FRASERS PROPERTY AUSTRALIA (FPA)  
& WINTEN PROPERTY GROUP (WPG)

# MACQUARIE PARK COMMERCE CENTRE PEDESTRIAN ANALYSIS

REV	DATE	DETAILS
A	10/01/2018	Macquarie Park Commerce Centre, Pedestrian Analysis
B	31/01/2018	Final
C	08/02/2018	Revised with comments
D	10/04/2018	Revision to laneways
E	02/07/2018	Response to Council Request for Information

Figure 3.1 Survey Locations and Pedestrian Movements

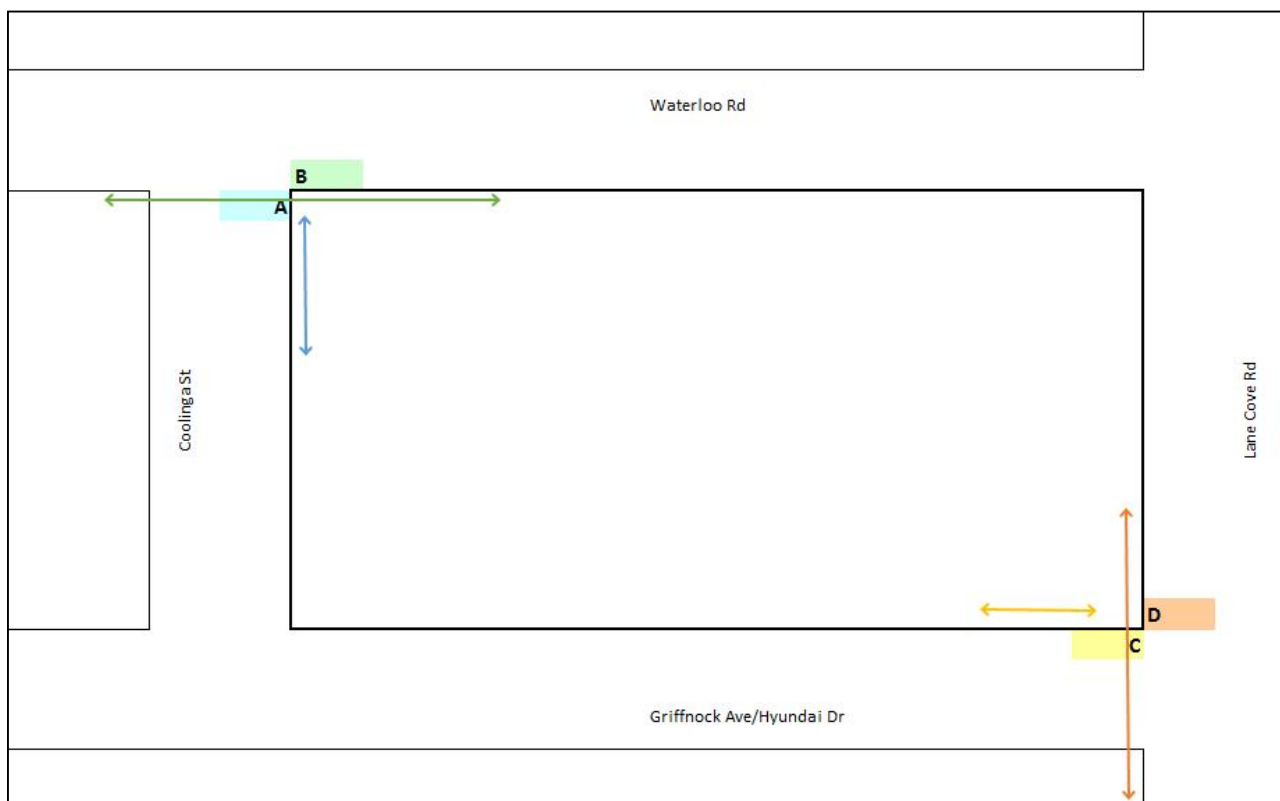
RFI – CITY OF RYDE	RESPONSE
The survey was conducted on a single day (Tuesday 15min in the am and 15min in the pm). It is based on 1X 15-minute spot survey in each identified 4 locations around the site and could hardly be treated a representative sample.	A Seasonal Variation assessment was undertaken, see Section 3.2 and Section 5.1, updated Table 5.1 and Figure 5.1. This ensures that the survey data is appropriate for this assessment for a typical day.
The Pedestrian Study is only limited to current pedestrian count and projections to 2029 based on a growth rate of 3%. per year. It is not clear whether the projection rate incorporates the residential population and employed population.	WSP assumed a general rate in accordance with the scale of growth experienced across the Sydney transport network.
The Report does not factor in the pull factors that the site will provide in the short term such as the additional retail space, open space and short cuts in the southerly direction and the long-term changes in density and potential residential mix in Macquarie Park.	Within the base pedestrian movements, ‘shortcutting’ over the site has been accounted for, and the trip generation for retail does account for any ‘pull’ for existing employment uses.

Figure 5.1 Static Pedestrian Analysis – LOS

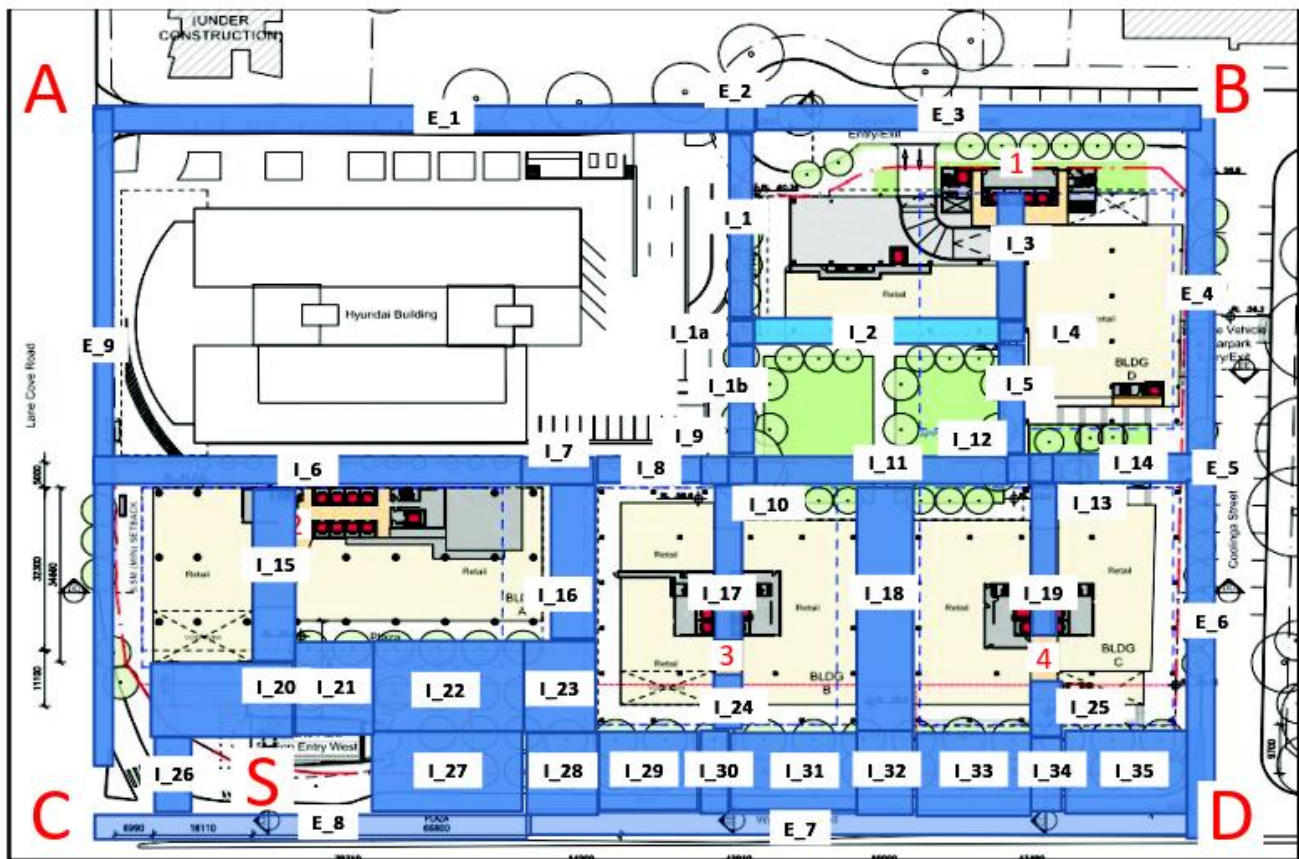
The laneway width is only part of the concern, more critical is the need for building separation.	Lane way width and building separation have been increased in the revised plans, see Figure 5.1.

As can be seen in Table 5.1 and Figure 5.1 all areas within the assessment are LOS A during the 2029 AM with development scenario, with the exception of link 'I\_2' which may be used as a restaurant and café seating area in the future, thus reducing the effective width of the area for pedestrians and as such producing LOS B. However, LOS B is still an acceptable LOS for a walkway, as shown in Table 2.1.
